Appendix 9-A

Review of SFR Package

- Roscoe Draw Example** – The image below is of Roscoe Draw, a tributary that enters the South Platte River just downstream of Roscoe.

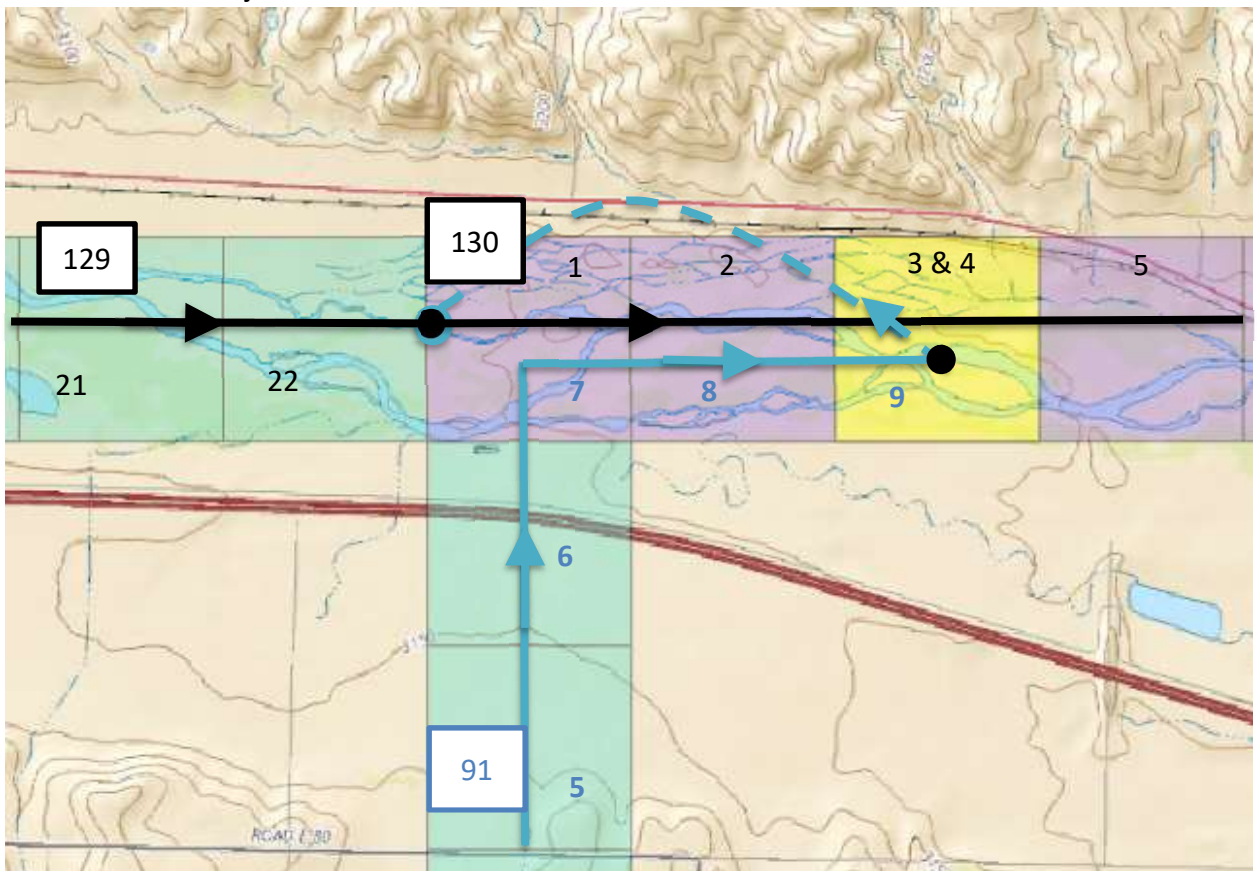
As the figure above shows, water from the South Platte flows downstream (to the east) from Segment 129 to 130. Water from Roscoe draw flows north, then east in Segment 91. Segment 91 is supposed to connect to the South Platte at the start of Segment 130, but proceeds east two cells. Additionally, the South Platte has two reaches (3, and 4) in

segment 130 in the same cell, thus doubling the gains or losses in this cell. This is a small issue, but could locally affect water levels and stream gains.

- **South Platte and Drains near Sutherland.** The figure below shows the South Platte and two drains near Sutherland Reservoir. The drain located west of Sutherland is currently modeled as entering the South Platte River 3 miles too far east.

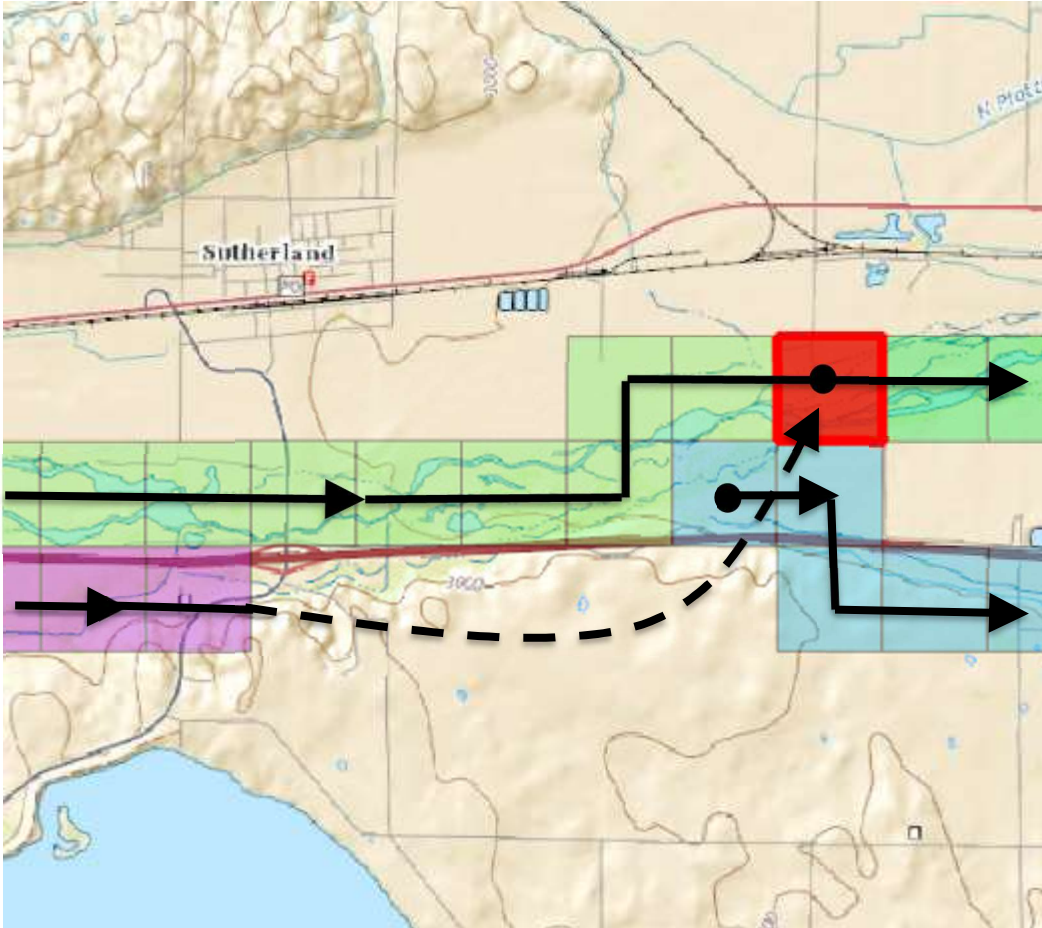
Rebuilding the stream package to address these issues will likely improve model calibration locally near the river by correctly modeling the system as it exists in the real world.

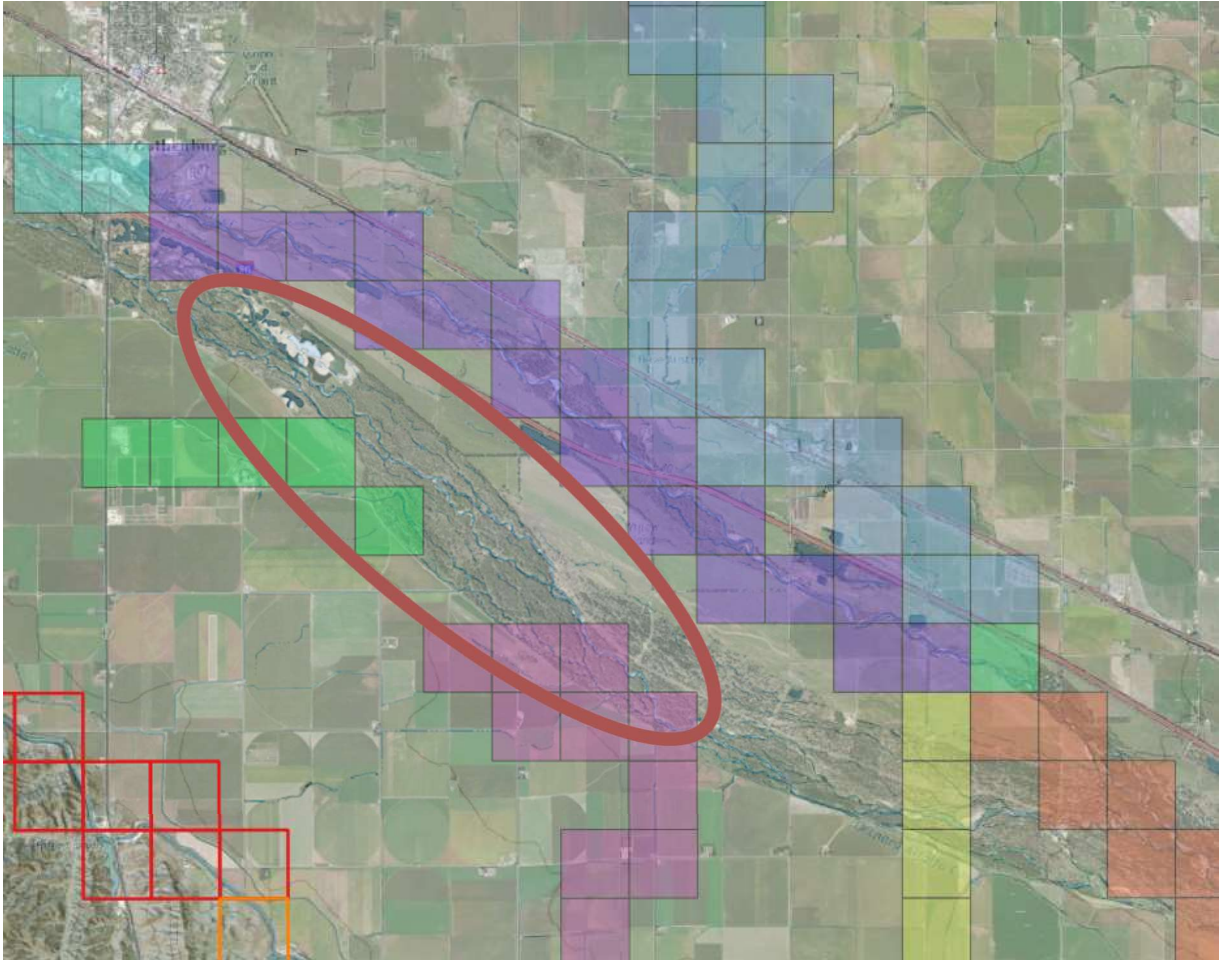
- 2) Not all the channels of the Platte River are modeled. The figure below shows the stream package near Gothenburg where there are two distinct channels associated with the Platte River. Currently, COHYST only models one channel which is designed to be representative of the river. I would recommend adding two channels to better match the real world.
